RENESAS TECHNICAL UPDATE

Product Category	MPU/MCU		Document No.	TN-RZ*-A0079B/E	Rev.	2.00
Title	RZ/G2H, RZ/G2M V1.3, RZ/G2M V3.0, RZ/G2N and RZ/G2E Additional explanation for Electrical Characteristics		Information Category	Technical Notification		
Applicable Product	RZ/G Series, 2nd Generation RZ/G2H, G2M V1.3, G2M V3.0, G2N and G2E	Lot No.	Reference Document	RZ/G Series, 2nd Generation User's Manual: Hardware Rev.1.01 (R01UH0808EJ0101)		
		All lots

Additional explanation for "Hardware Electrical Characteristics Common to RZ/G Series, 2nd Generation products".

Figure 73.3.2.2 power-up/down sequence without DDR backup [RZ/G2E]

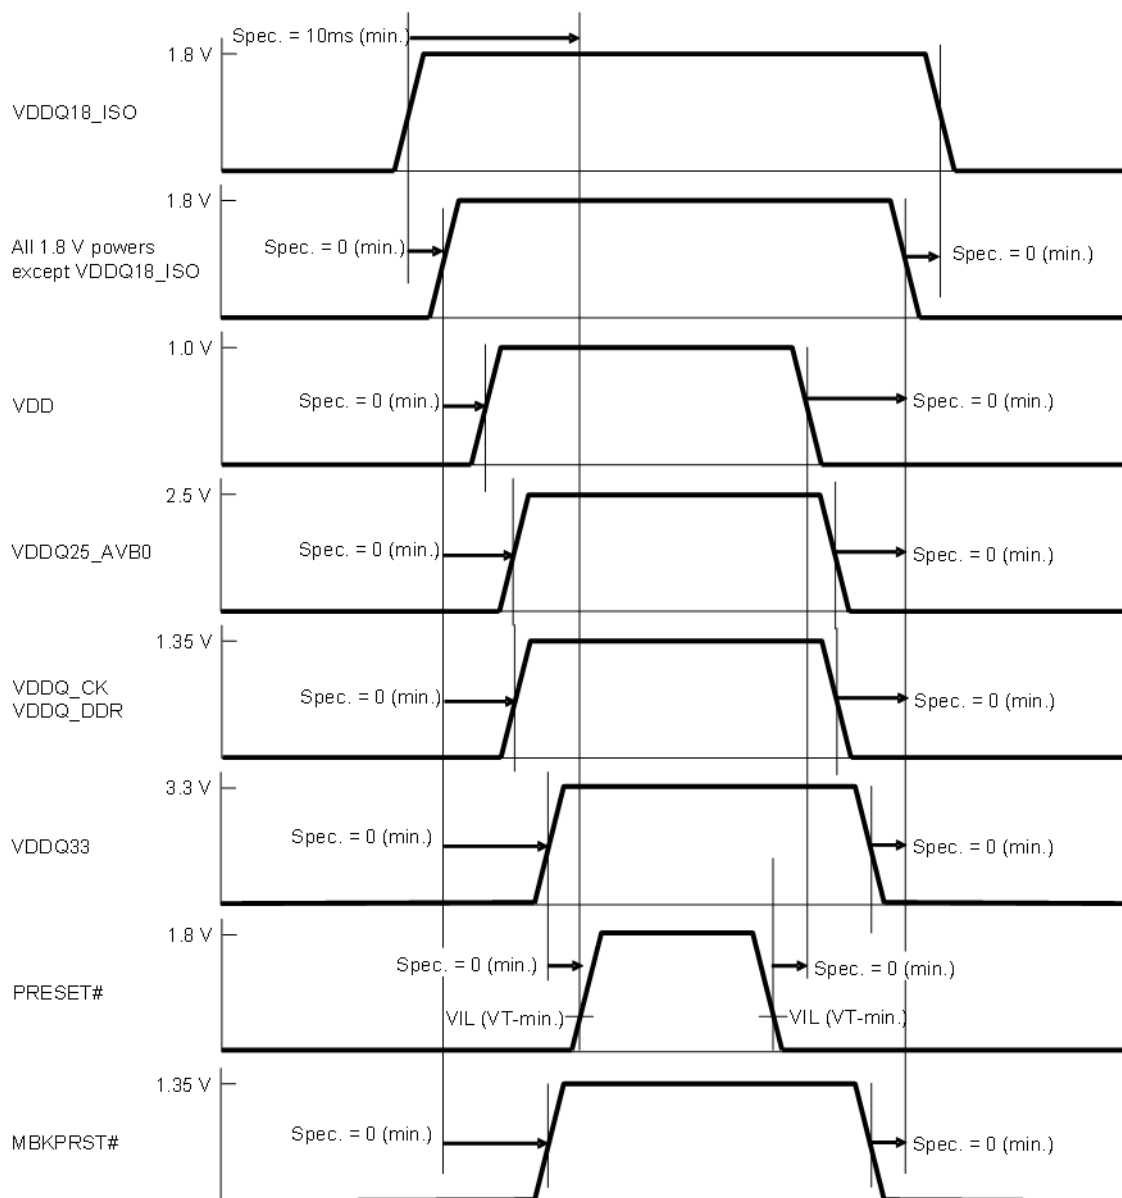
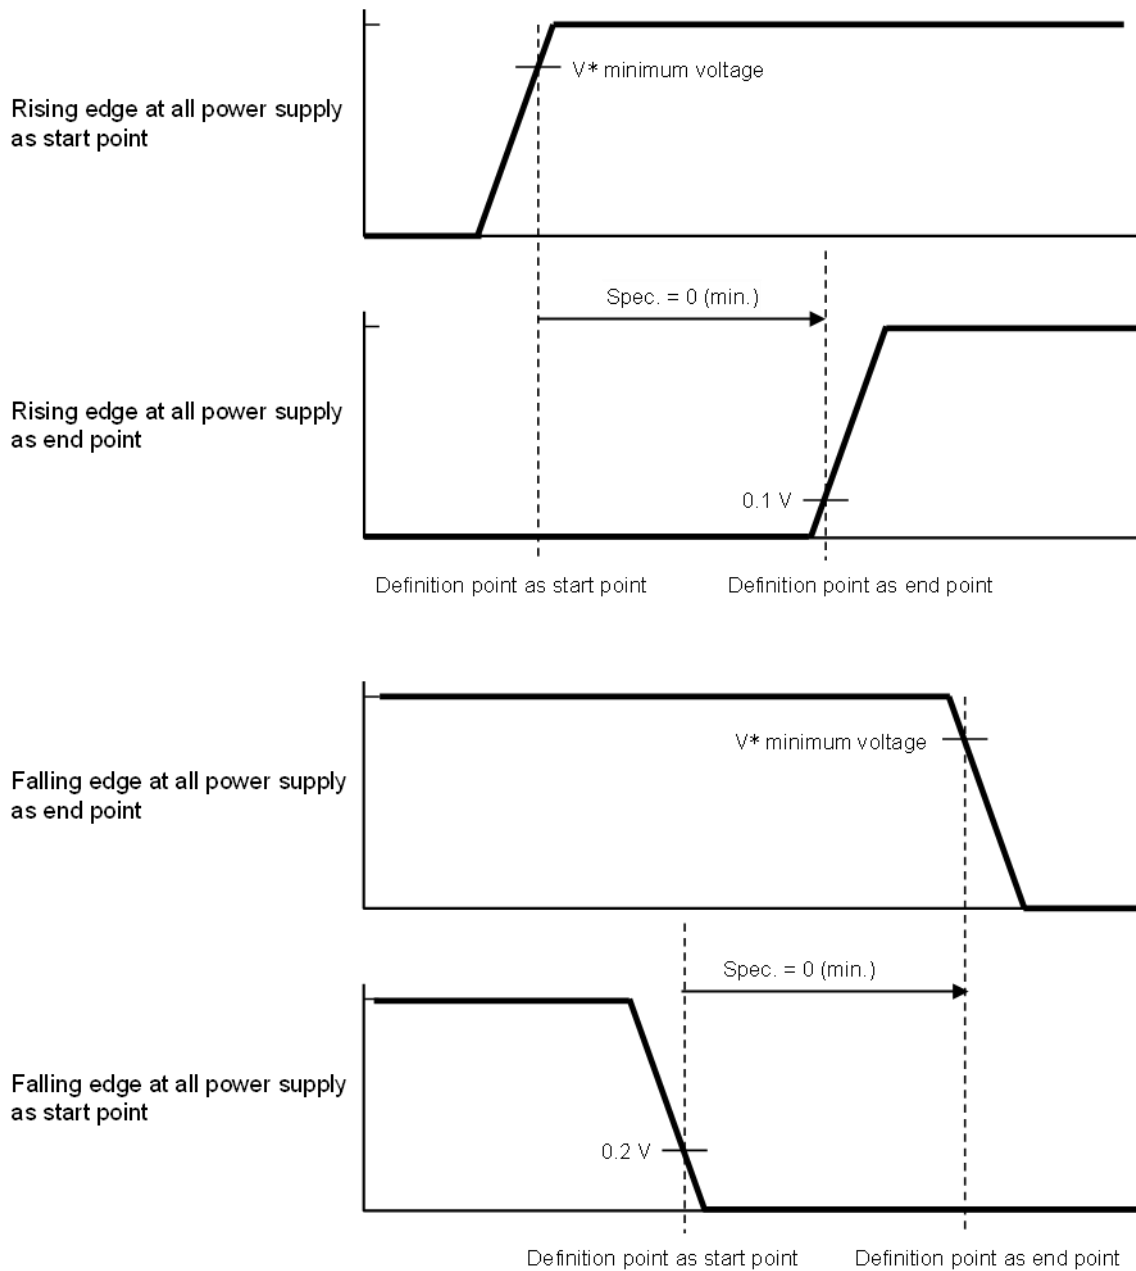
6. 73.3 Sequence of Turning On/Off Power Supplies, Page 73-15, 73.3.2 Sequence of Turning On/Off Power Supplies for [RZ/G2E]. (2) RZ/G2E power-up/down sequence without DDR backup. Figure of Note are corrected.

Notes: 1. Maximum time from first power rising to last power rising is 300ms.

Change notes to refer to the section that defines the specification.

- Notes: 1. Refer to Figure 73.3.4.1 for the maximum time from first power rising(falling) to last power rising(falling). Note that at power-on reset, refer to the specifications shown in section 73.5 “Clock and Reset Timings”.
2. MBKPRST# input must track VDDQ_DDR/VDDQ_CK during VDDQ_DDR/VDDQ_CK power-up.

Figure 73.3.3.1 Period for Power Rise for [RZ/G2E]

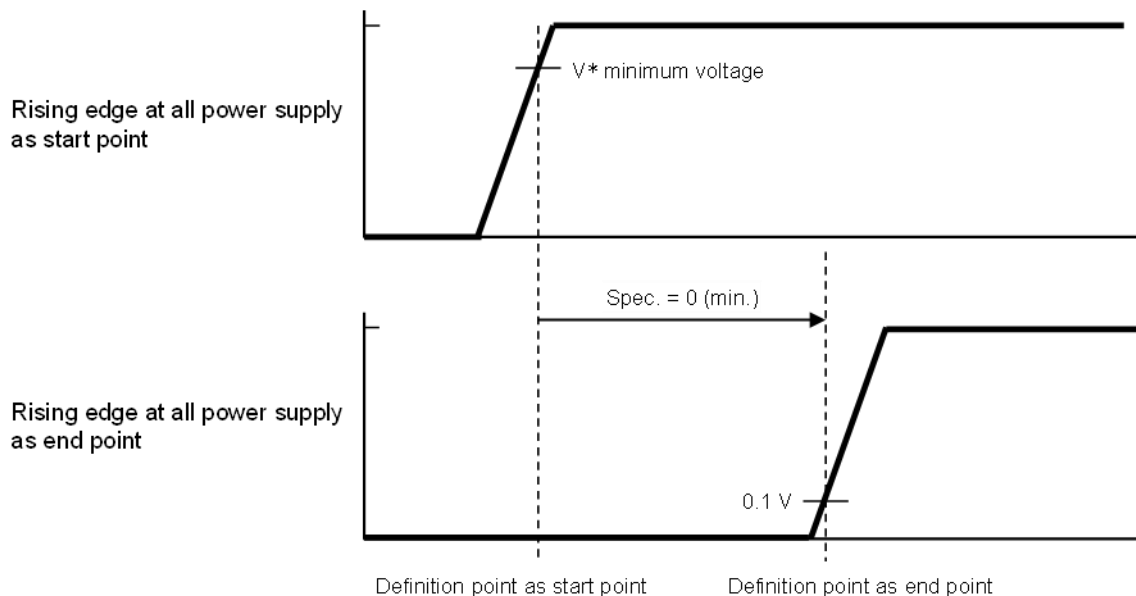
7. 73.3 Sequence of Turning On/Off Power Supplies, Page 73-16, 73.3.3 Wave form definition for power sequence [RZ/G2E]

Added figure number and figure title.

Figure 73.3.4.1 Power On and Power Off Wave Form [RZ/G2E]

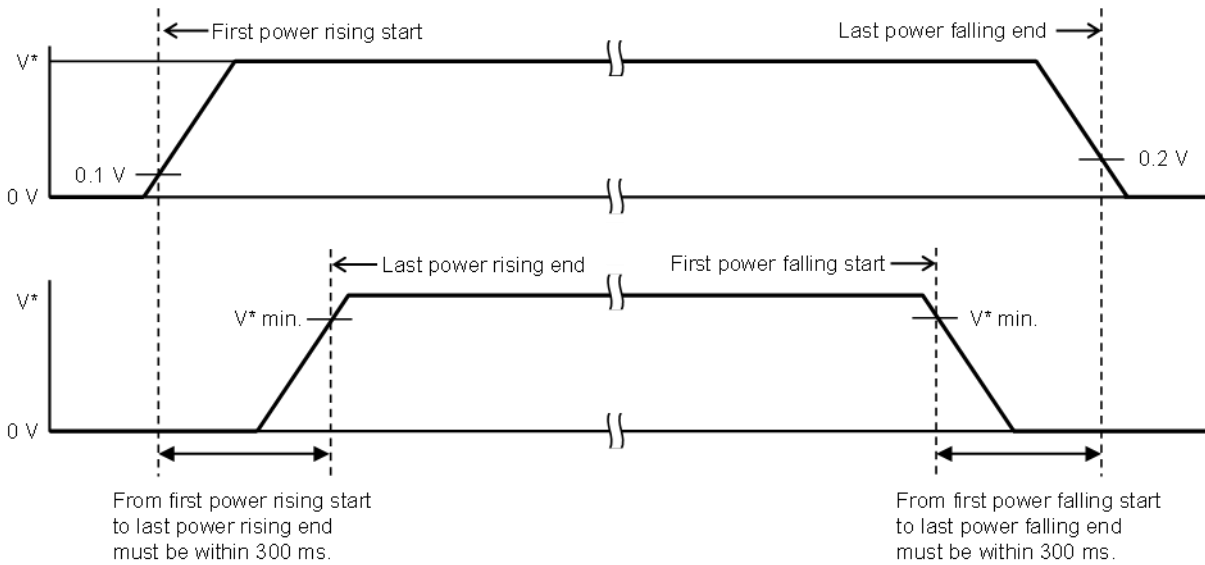
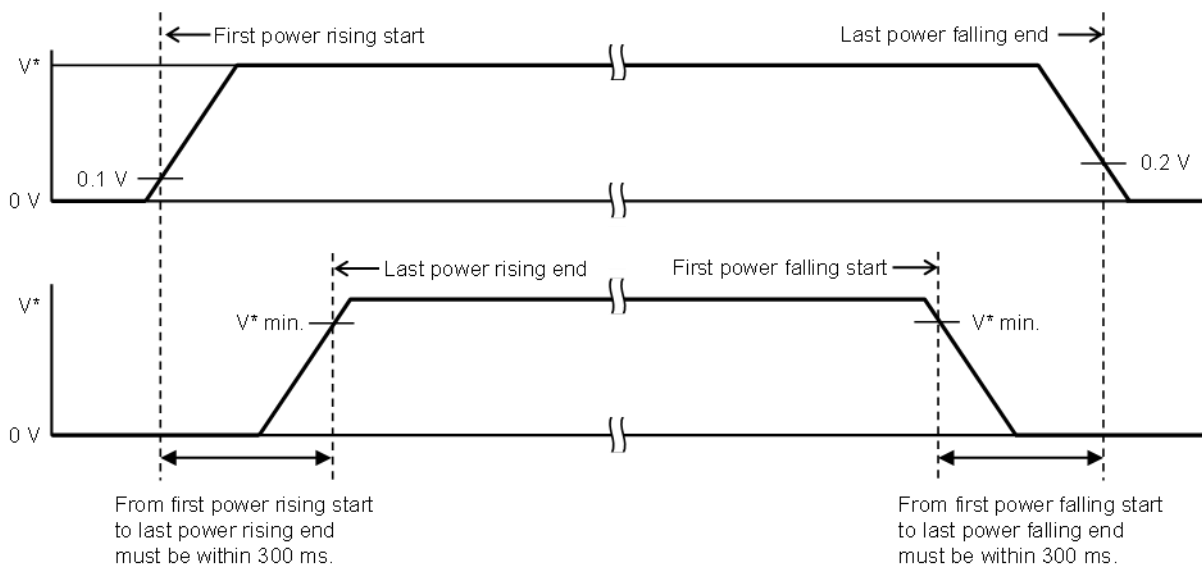
9. 73.3 Sequence of Turning On/Off Power Supplies, Page 73-17, 73.3.4 Power On and Power Off Wave Form [RZ/G2E]

Added figure number and figure title.

Note: For all V^* , power off state must be 0 V (GND), power rising must be started from 0 V and power falling must be ended to 0 V (excluding DDR-SDRAM power-supply backup state).
 Periods from 0 V to 0.1 V at power-on and from 0.2 V to 0 V at power-off should be shortened as much as possible.
